**IMS Systems, Inc.**  
10521 Perry Highway  
Suite 310, 3<sup>rd</sup> Floor  
Wexford, PA 15090  
Main: (724) 940-7160  
Fax: (724) 940-7179

Item 2.3: Drawing 5321-035 A1 has the correct G18 Sintered Tungsten material listed. All other drawings that list S18 as the material will be revised, only to reflect the use of the G18 material. The drawings, after revisions will be available to the NRC for your review, if requested. (Dwg. 5321-035 A1 attached).

Compact cylinder, double acting  
156003  
ADVU-25--P-A

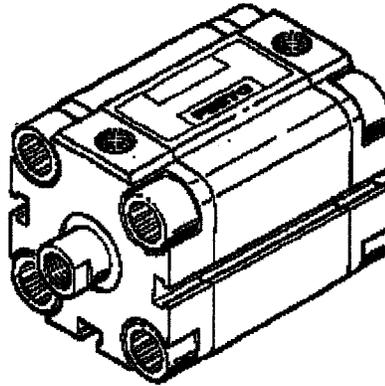
Item 7.2: The air pressure we require is between 4.5 and 8 bar, although all of the components including the shutter actuator are designed and approved to operate with 10 bar.(see attached file). I can explain why page 7 of the application indicates that the shutter actuator is limited to 8 bar. We require that the customer supply a minimum of 4.5 bar and a maximum of 8 bar. This gives us the ability with the pressure regulators and filters to regulate for the optimum performance of all the peripheral devices associated with the measuring system.
